Minimum TX Launch Power in OMA Shall Be Constrained by TECQ

(In support of comment #11)

Yi Tang, Cisco

IEEE P802.3dB TF Interim Meeting, 07/19/2021

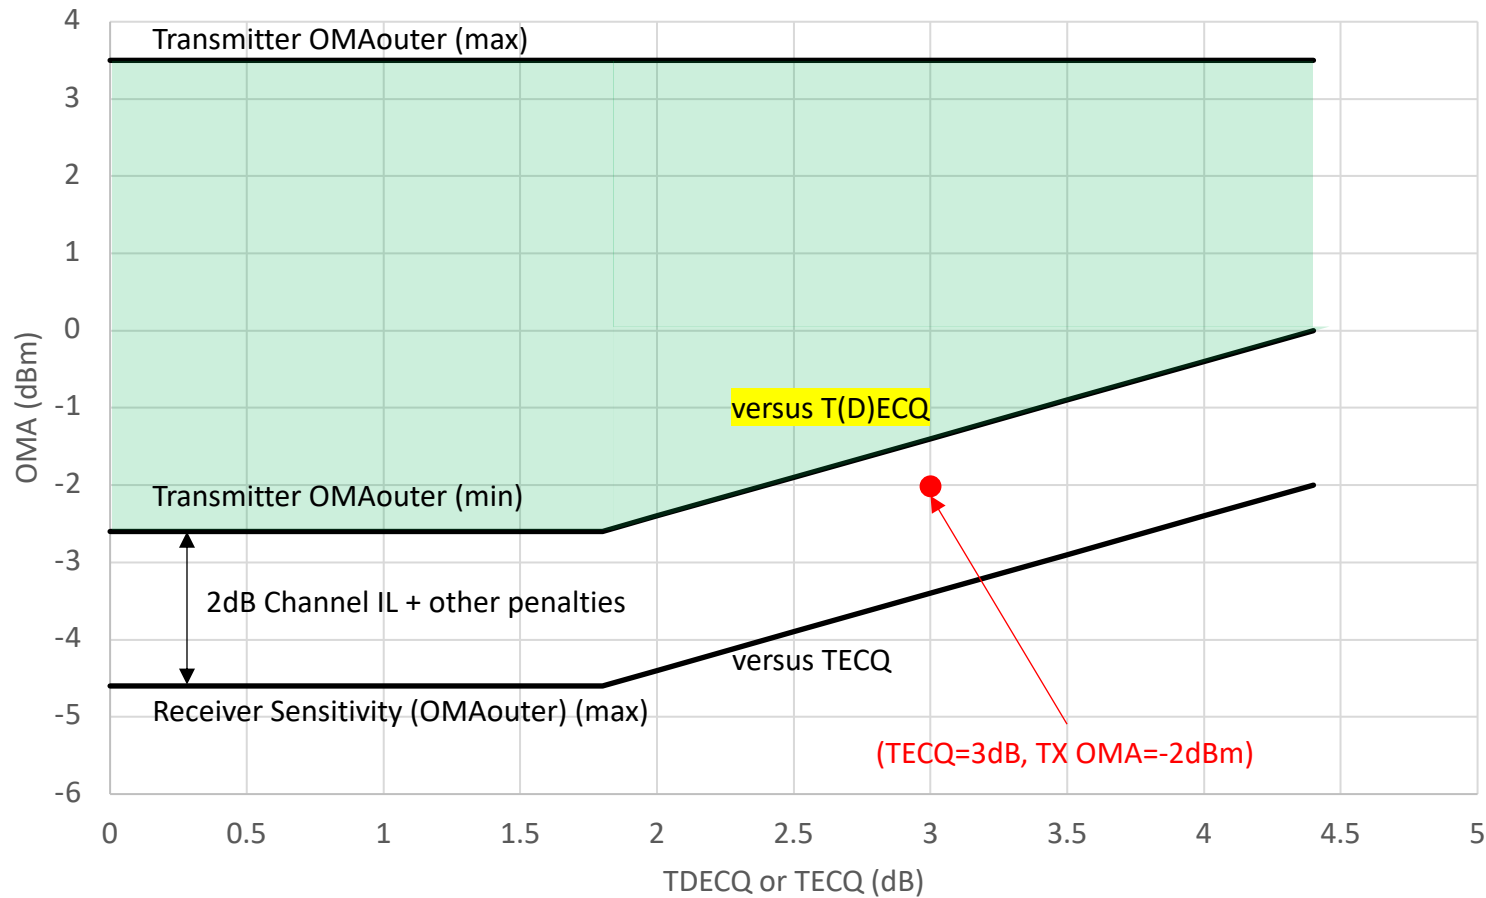
Interoperability Issue Posed by the Current Spec Gap

- Current spec allows transmitter to operate at min OMA despite of TECQ value – diagram on the right.
- With TX pre-distortion, TECQ can be higher than 1.8dB and even worse than TDECQ.
- Majority of 2dB channel loss budget comes from connectors loss and apply to non-fiber/short fiber applications.
- Receiver sensitivity spec doesn't require receiver to accept low power signals with high TECQ.

Proposed Change

- Constrain transmitter OMA by both TECQ and TDECQ to guarantee that transmitters operate in the green region.
